Request for Additional Information No. 413(4772), Revision 1, Supplement 4

U. S. EPR Standard Design Certification

SRP Section: 07.08 - Diverse Instrumentation and Control Systems

Application Section: ANP-10304

Figure 07.08-23-1

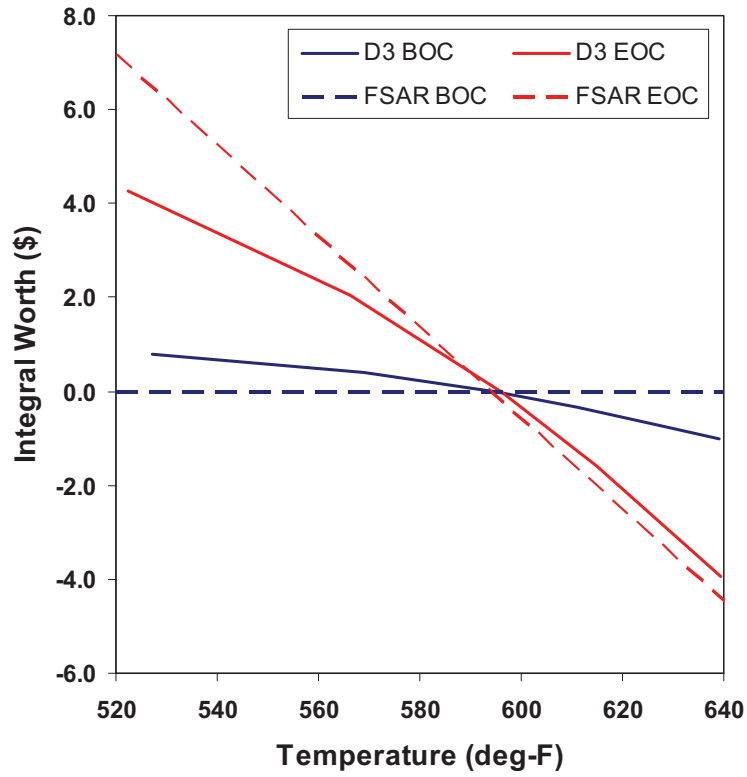
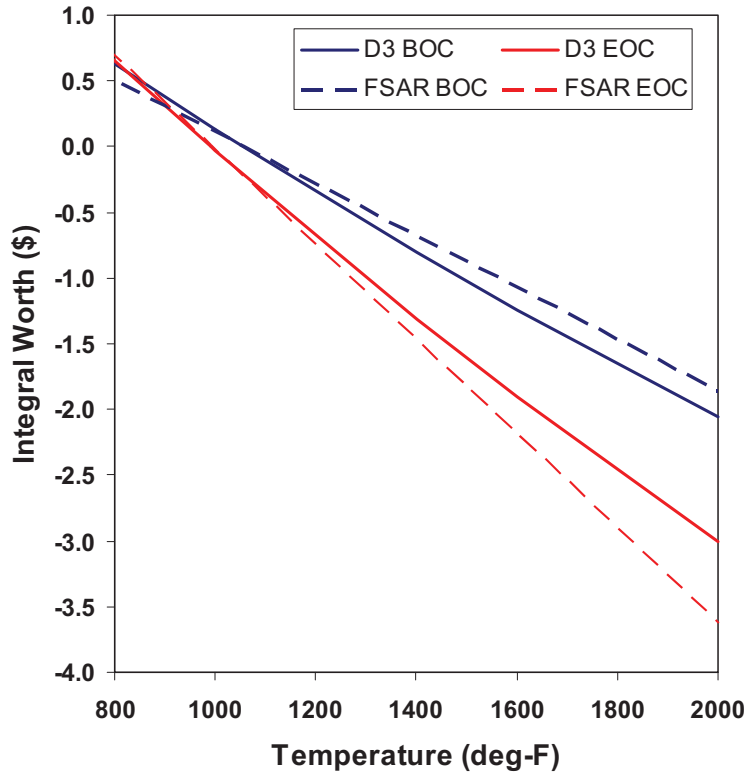
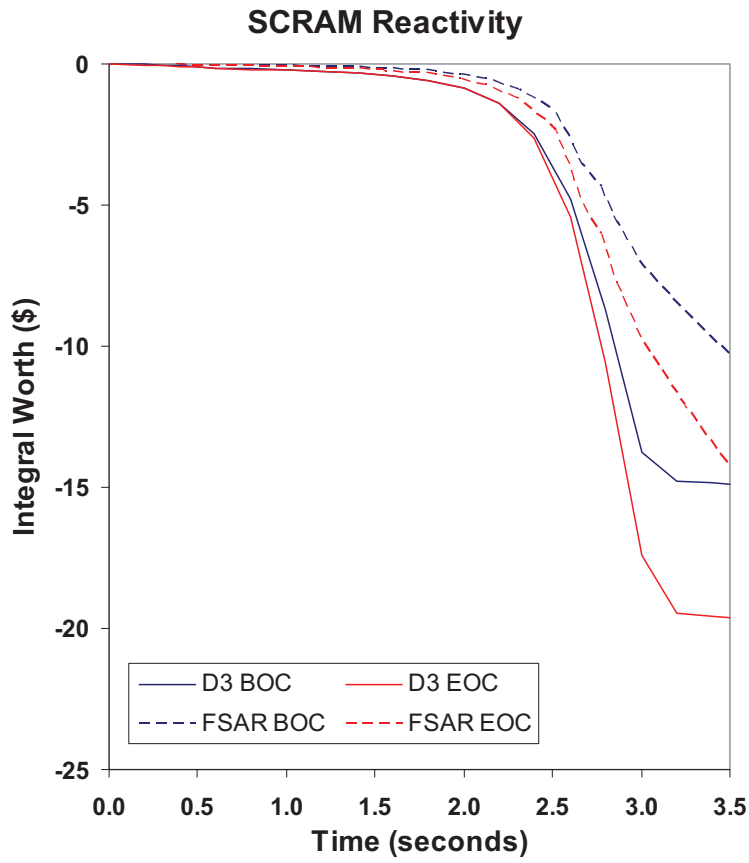
For the D3 analysis provided in “U.S. EPR Diversity and Defense-in-Depth Assessment Technical Report” (D3-TR), ANP-10304, Revision 1 (ML093420199), Appendix A, the following additional information is needed for the MSLB case with PS SWCCF at full power conditions:

a) Demonstrate that a return to criticality does not occur following reactor trip,

The FSAR Tier 2, Chapter 15 analysis identifies the main steam line break (MSLB) initiated from HZP as the limiting Steam System Piping Failure event, resulting in a small number of fuel failures due to the SAFDL on cladding strain (Local Power Density) being exceeded. [NOTE: HZP is typically more limiting than HFP because the absence of decay heat will allow greater cooldown of the RCS and therefore an increase in moderator temperature reactivity.] Therefore, additional information is needed for the case with PS SWCCF at full power conditions for the staff to complete its review.

The main steam line break (MSLB) event was not specifically analyzed with S-RELAP5 for the diversity and defense-in-depth (D3) assessment but was evaluated by a quantitative comparison to the FSAR Tier 2, Chapter 15 analysis using best estimate assumptions. Hot full power (HFP) was assumed as the initial condition in all the D3 assessments. HFP represents the normal plant operating condition and is consistent with best estimate conditions. To establish whether the core would return to critical following an MSLB, the temperature at which the core would be critical under best-estimate assumptions was determined. For this calculation, the PRISM reactor analysis tool was used to determine the reactor state (k_{eff}) as a function of temperature with all rods in (ARI), HFP xenon, and at end of cycle (EOC). The cases employ both thermal and Doppler feedback mechanisms to determine the reactivity response as a function of inlet temperature at isothermal conditions. This limiting set of conditions coincides with an equilibrium cycle, and the results are summarized in Table 07.08-23-1.

These data illustrate that the temperature at which a return to critical is expected to occur post-MSLB is $\sim 105^\circ\text{F}$ under best-estimate core conditions at EOC, ARI with HFP xenon conditions. This is the basis for the conclusion that a return to power would not occur following a MSLB considering a software common cause failure (SWCCF).

The difference between this analysis and that documented in the U.S. EPR FSAR Tier 2, Chapter 15 involves the use of best estimate moderator temperature coefficient (MTC), Doppler fuel temperature coefficient (DTC), and scram reactivity. The difference in these parameters between the best estimate and FSAR Tier 2, Chapter 15 values are given in Table 07.08-23-2 and Figures 07.08-23-1 through 07.08-23-3.

The U.S. EPR FSAR Tier 2, Chapter 15 values include biases and account for calculational uncertainties. The best estimate values are determined from the core analysis models for projected Cycle 1 and the equilibrium cycle. The scram reactivity use in the D3 analysis does not assume a stuck rod.

Figure 07.08-33-1—Comparison of PCT: RCP NO Trip (New) vs. RCP TRIP (Original)

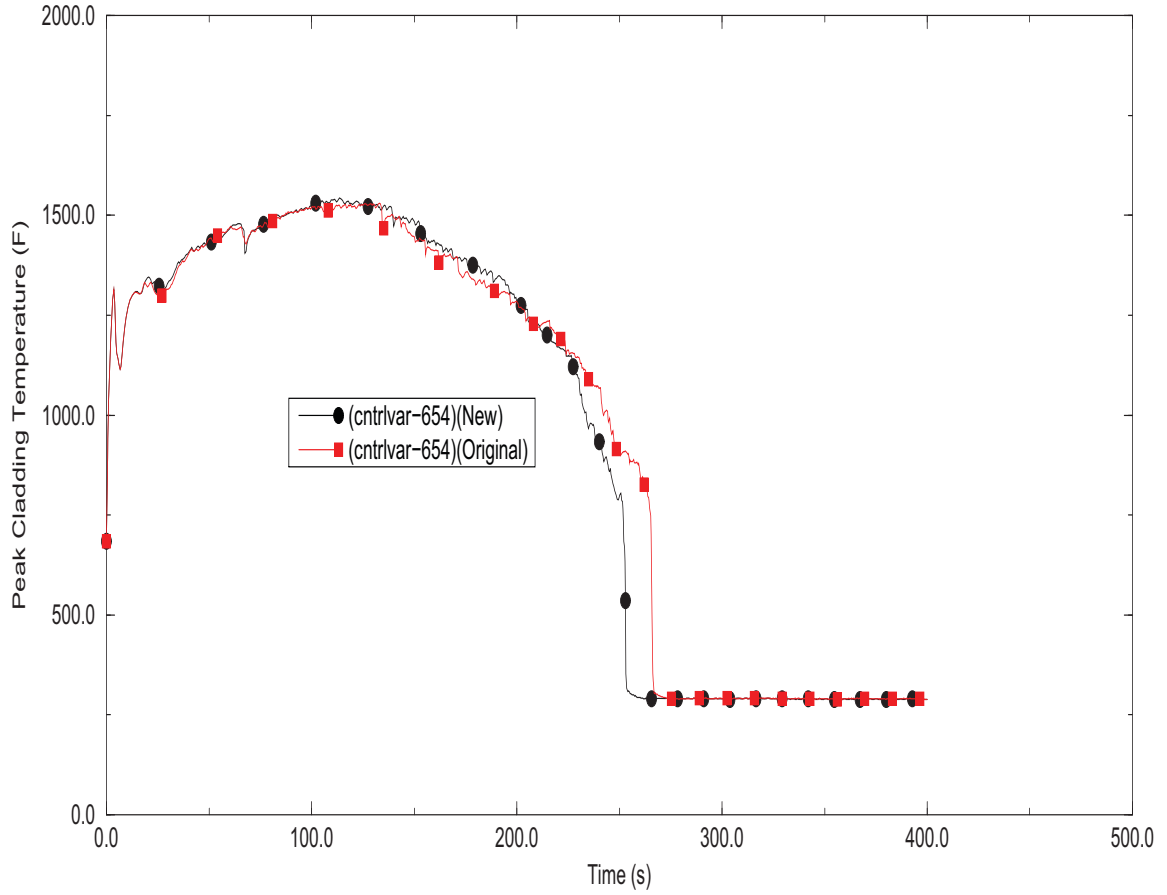
For the large break loss of coolant accident (LBLOCA) event described in ANP-10304 Rev 1 Section A.3.7.3, provide the following additional information:

- a) A summary of the sensitivity calculation results referred to in Section A.3.7.3.1 that demonstrate the conclusion that continued operation of RCPs does not significantly affect the LBLOCA results, and
- b) An assessment of the effects of continued operation of the RCPs during two phase and vapor LBLOCA conditions on the RCPs themselves, i.e., cavitation or overspeed damage resulting in subsequent unavailability of the RCPs.

A sensitivity calculation was performed to assess the effect of not actuating this automatic reactor coolant pump (RCP) trip on peak cladding temperature (PCT). This -study remodels the automatic RCP trip for selected cases from the U.S. EPR uncertainty analysis. These realistic large-break loss-of-coolant accident (RLBLOCA) cases are representative of an initial fuel cycle and were performed in accordance with ANP-10278, Revision 0. Since performing this sensitivity study, the RLBLOCA analysis was updated in accordance with ANP-10278, Revision 1.

The results of the sensitivity study show that not actuating the automatic RCP trip has a minor impact of <30 °F on the PCT and causes no discernible differences in break flow between original calculation cases with automatic RCP trip and new sensitivity cases without automatic RCP trip. In the RLBLOCA analysis, with the automatic RCP trip case, the pump trips at approximately 10 seconds.

Figure 07.08-33-1 is a comparison of PCT between new and original cases and shows that the deactivation of the automatic RCP trip has a minor impact (<30 °F) on the PCT calculation.

Results for Larger SBLOCA Breaks: 6.0 inch DIAMETER Break
Figure 07.08-34-1—SBLOCA 6.5 inch diameter Break: Loop Seal Clearing Time

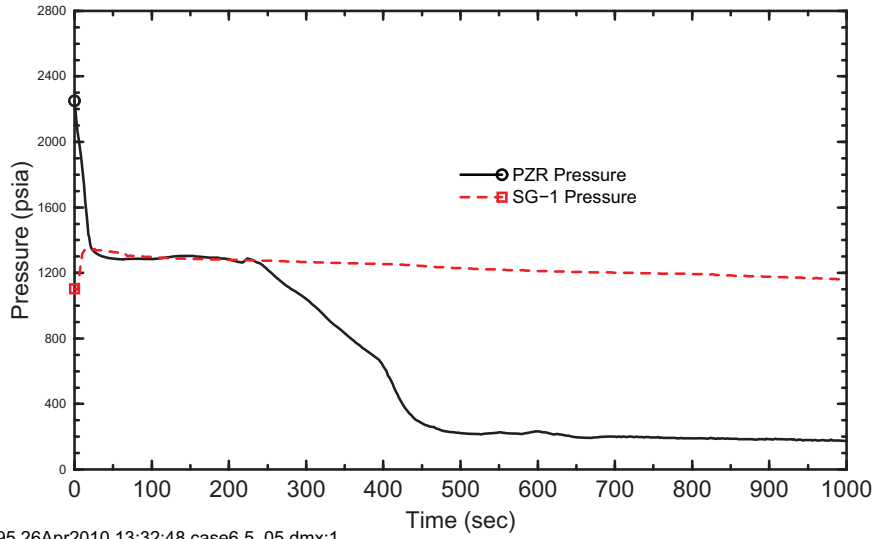
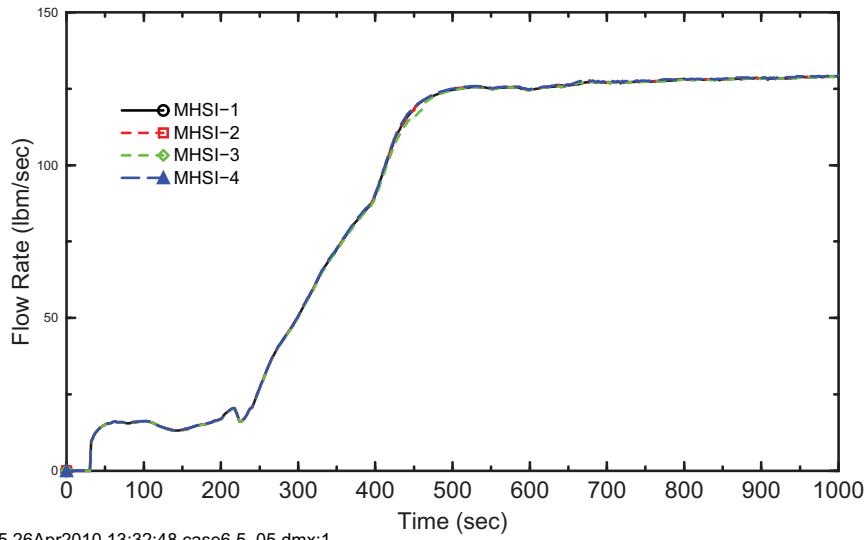
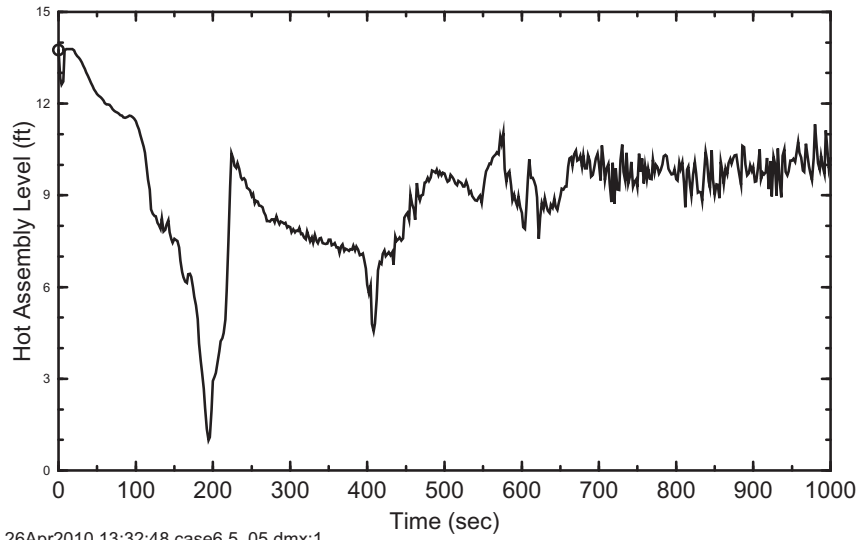
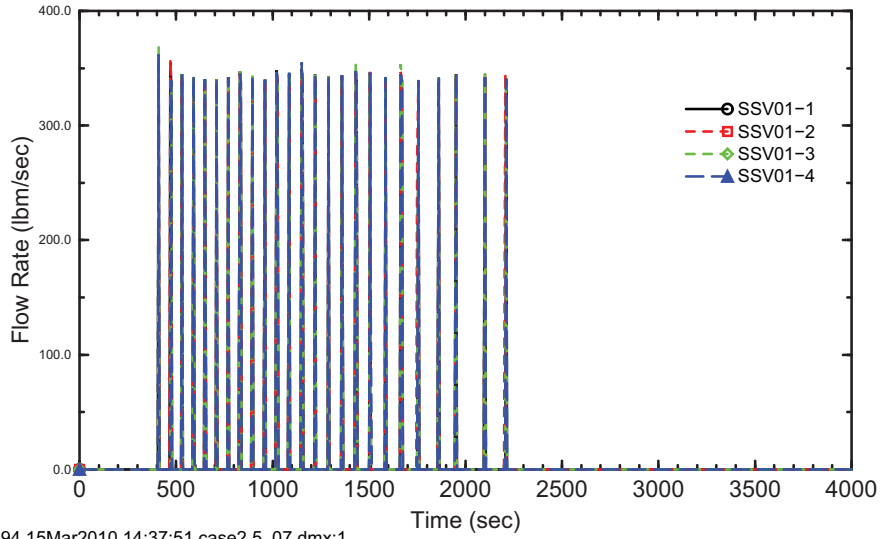
Provide a resolution of whether the turbine bypass system may be relied upon for partial cooldown during a SBLOCA with SWCCF in the PS. If manual operator actions are required to be performed, provide the timing requirements and a description of the operator actions, including whether such operator actions are covered by existing plant operating procedures or symptom-based EPGs.

ANP-10304 Rev 1 Section A.3.7.3.2 describes a condition where the MSRT partial cooldown function is unavailable during a SBLOCA with SWCCF in the PS and the turbine bypass system provides the partial cooldown function, as long as the MSIVs remain open. The applicant notes that an on-going review could affect the use of the turbine bypass system during SBLOCA. The staff is not able to identify design descriptions that would permit sufficient understanding in order to complete the safety evaluation.

SBLOCA breaks at the upper end of the spectrum rely less on the steam generators (SGs) to remove primary energy. Figure 07.08-34-1 shows that decay heat is removed through the break; the loop seals clear early in the transient, opening the path for the RCS depressurization. Figure 07.08-34-2 shows that the RCS depressurizes to the MHSI actuation signal independent of the SG ability to remove heat. Figures 07.08-34-3 and 07.08-34-4 show how as the RCS

depressurizes further, the MHSI flow overcomes the break flow and replenishes the core . Subsequent injection from the LHSI and accumulators assures extended core cooling.

For this break category, the highest calculated peak cladding temperature (PCT) is 1152°F for the 9.7-inch diameter break with reactor coolant pumps (RCPs) tripped at 60 seconds.
